PROPOSAL, CONTRACT, BOND AND SPECIFICATIONS

PHEASANT BRANCH GREENWAY ENHANCEMENT

CONTRACT NO. 9517

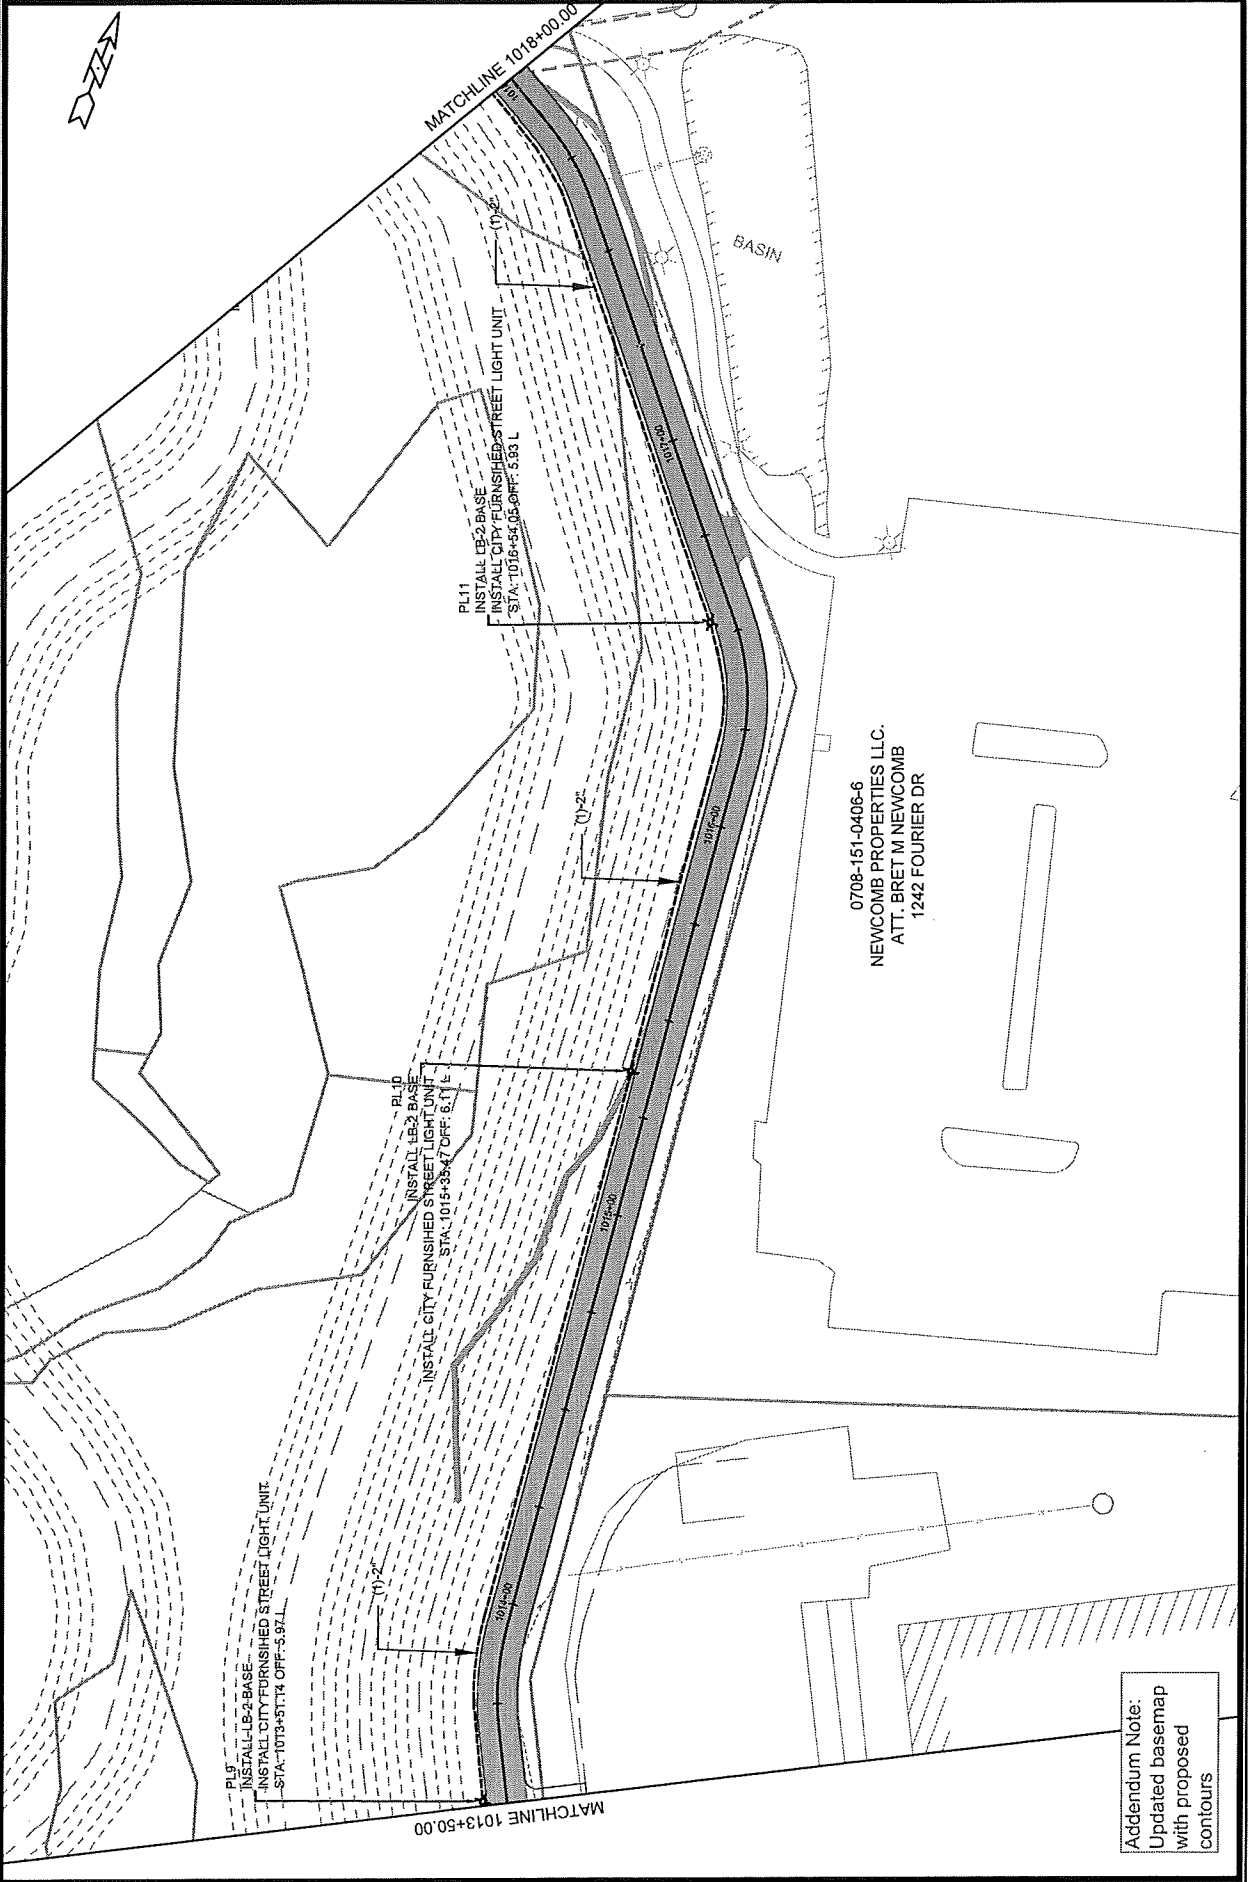
Addendum Note:  
Updated basemap  
with proposed  
contours

14370  
 E-5

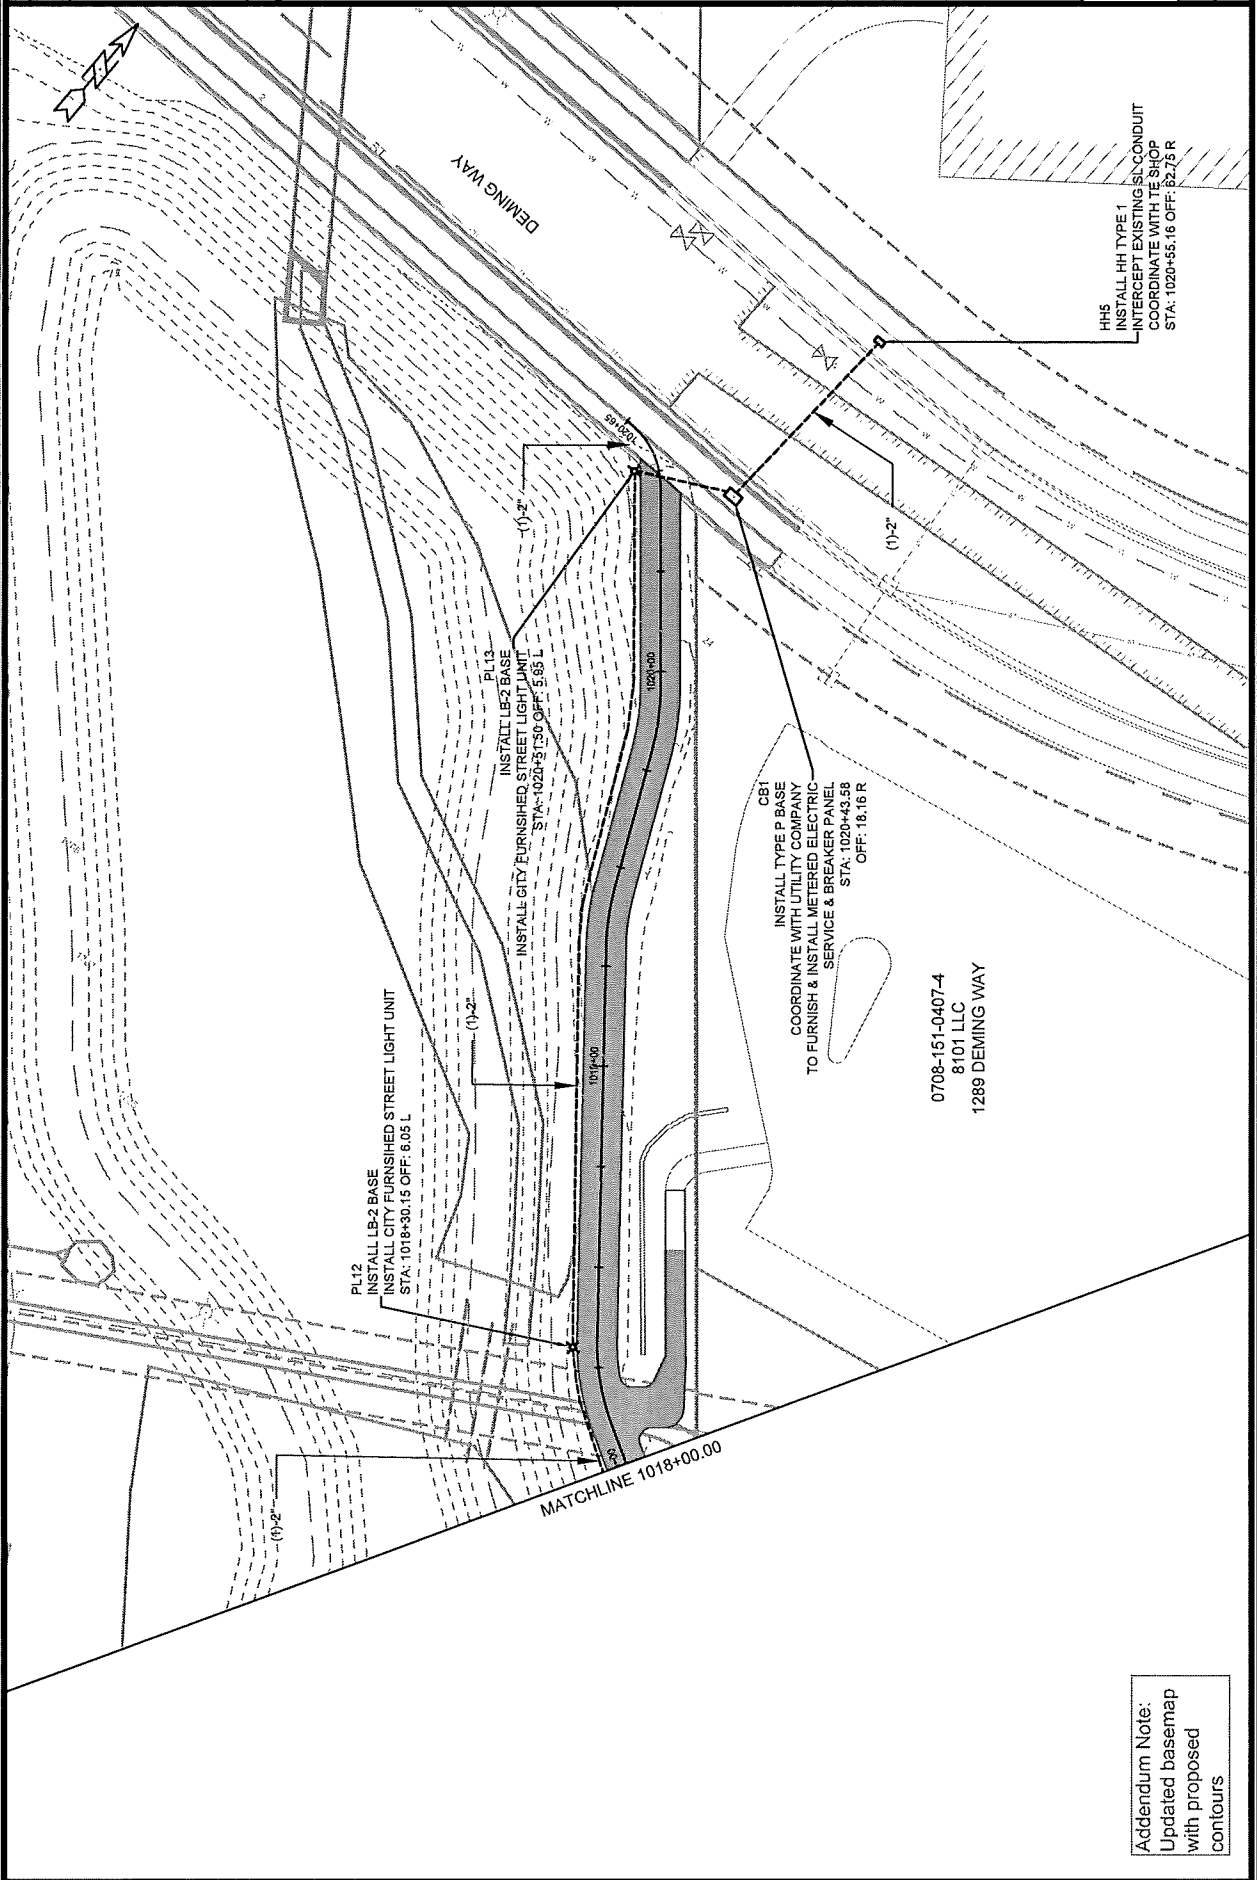
Addendum Note:  
 Updated basemap  
 with proposed  
 contours

14370  
 X32A

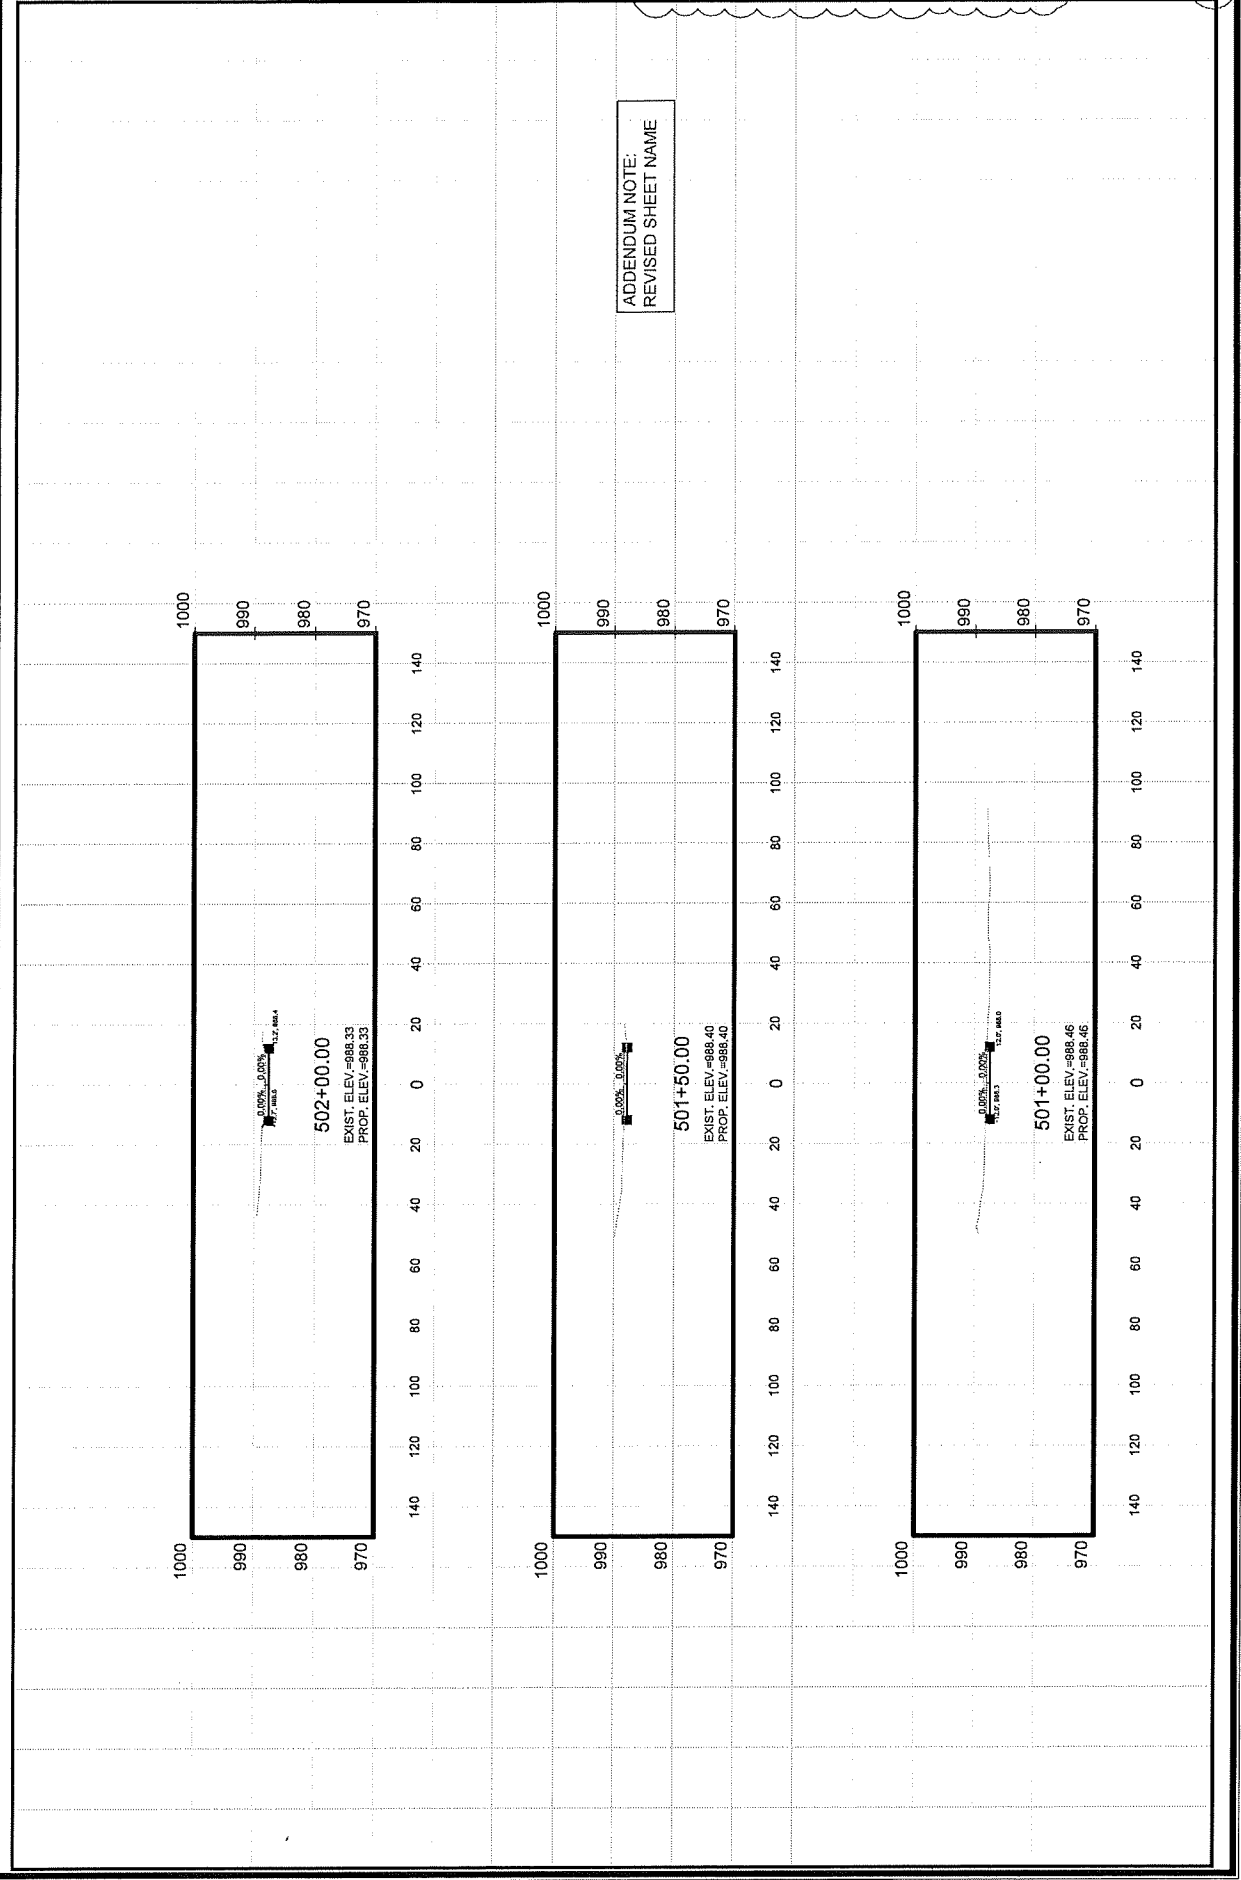
ADDENDUM NOTE:  
 REVISED SHEET NAME

14370  
 X34

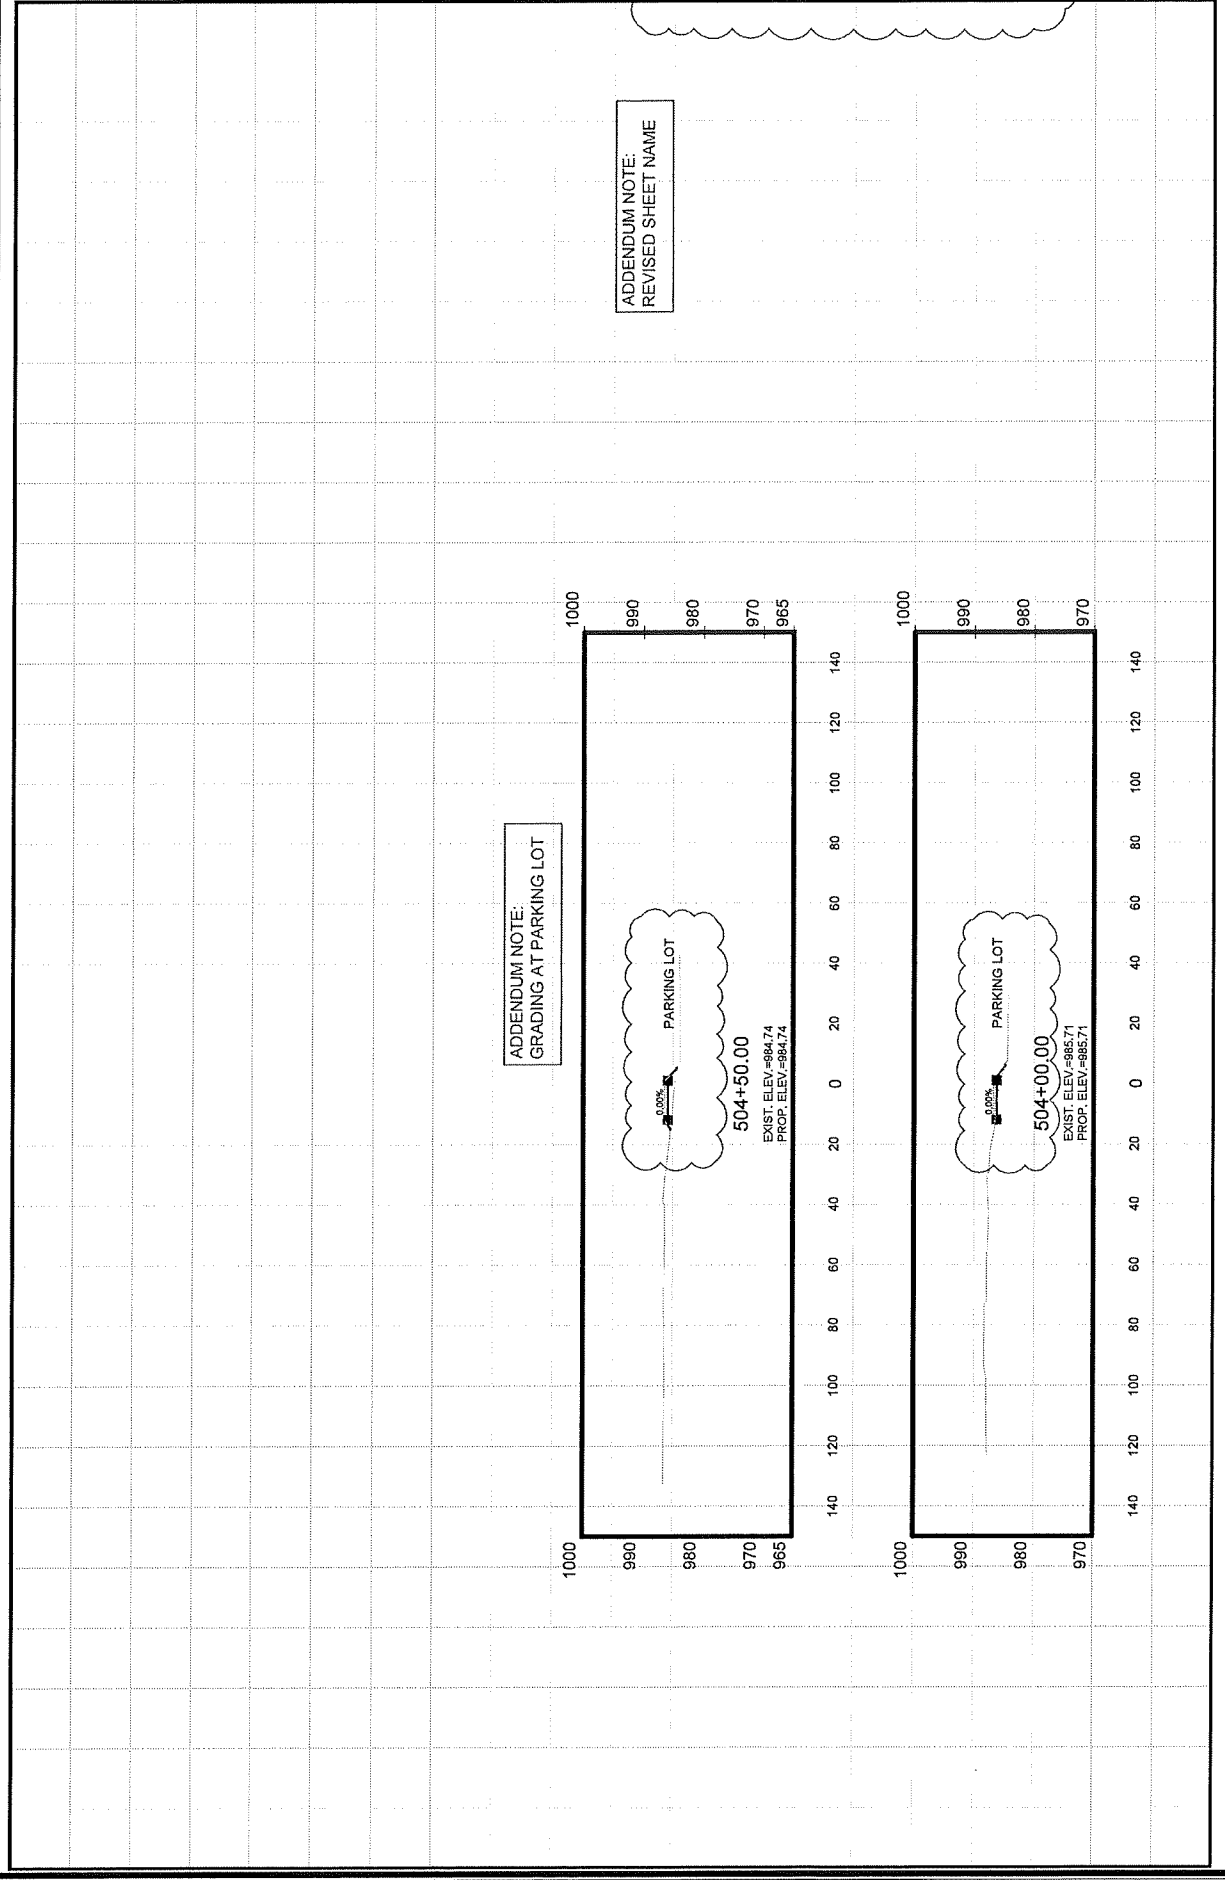
ADDENDUM NOTE:  
 GRADING AT PARKING LOT
